11-08 LATEST REVISION DATE  <i>Thomas E. McQuinn</i> APPROVED BY BRIDGE ENGINEER	<p><b>Iowa Department of Transportation Highway Division</b></p>	
	STANDARD DESIGN - 40' ROADWAY, 3 SPAN BRIDGES <b>CONTINUOUS CONCRETE SLAB BRIDGES</b> NOVEMBER, 2006	
SUPERSTRUCTURE DETAILS 150'-0 BRIDGE		J40-18-06

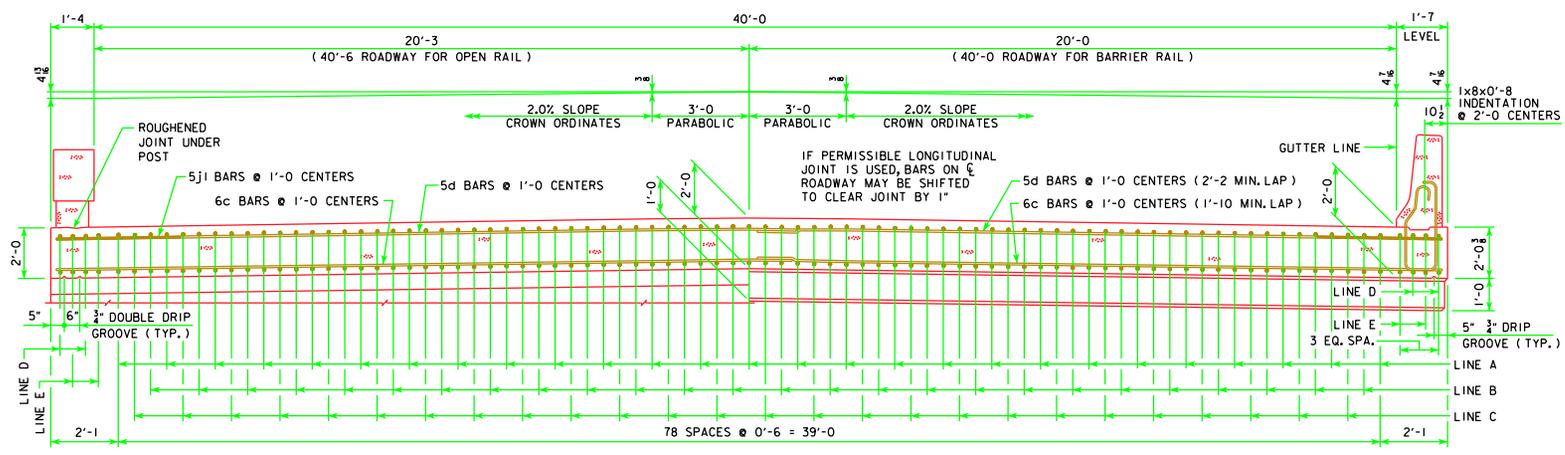
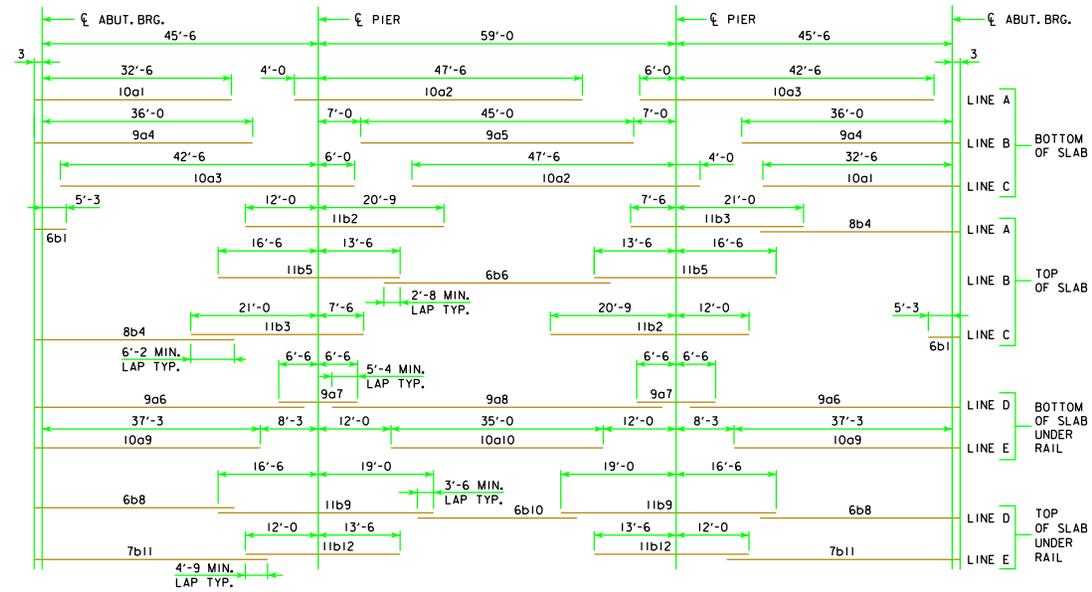
REVISED 11-08 - CHANGED DISTANCE OF END OF REBAR TO  $\bar{\bar{C}}$  OF ABUTMENT BEARING FROM 1'-4 TO 3 INCHES. REMOVED PERMISSIBLE LONGITUDINAL CONSTRUCTION JOINT.
